Addendum 1  
August 2004

# Specifications for Rotary Drill Stem Elements

API SPECIFICATION 7  
FORTIETH EDITION, NOVEMBER 2001

## Addendum 1 to Specifications for Rotary Drill Stem Elements

Figure H-6—External Height Gauge

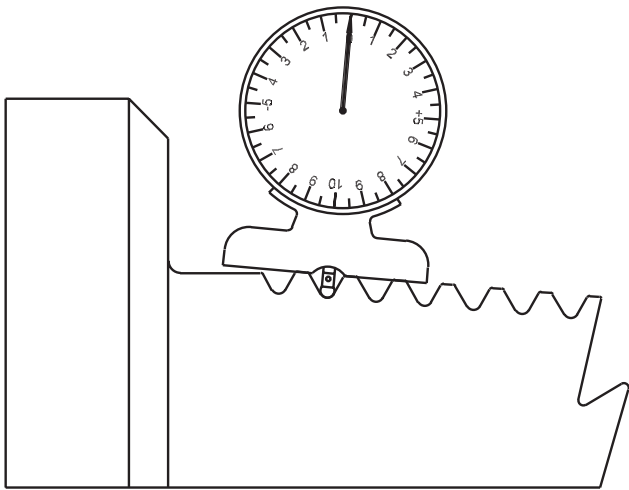
Thread height shall be measured with gauges of the type illustrated in Figure H-6 for external threads and internal threads as size permits, or the type illustrated in Figure H-7 for small

The contact ball shall be placed in the proper thread groove with the anvil in a line parallel to the axis of the thread and resting on the crests of the adjacent threads. For gauges of the type illustrated in Figure H-6, the gauge shall be oscillated through a small arc on each side of the position normal to the taper cone. For gauges graduated to measure the thread height error, the minimum plus reading or maximum minus reading on the indicator shall be taken as the thread height error. For gauges of the type illustrated in Figure H-7, the gauge can not be oscillated. Confirm that the gauge is well seated and properly centered in the groove before taking reading.

Figure H-8—Balance Dial Type Gauge

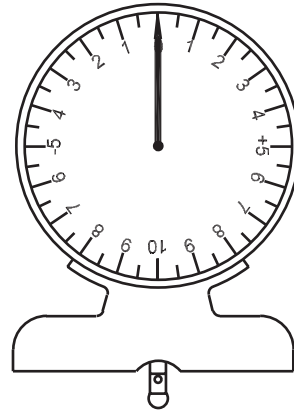
internal threads. Such gauges shall have indicators graduated to register the deviation in thread height, as illustrated in Figure H-8. Standard template as shown in Figure H-9 shall be provided for standardizing the height gauge. The standard templates shall be so constructed as to compensate for the error in measuring height parallel to the taper cone instead of parallel to the thread axis. For the U-groove on standard templates, the depth of the groove shall conform to the dimensions shown in Table H-2, column 5, within a tolerance of  $\pm 0.0002$  in.
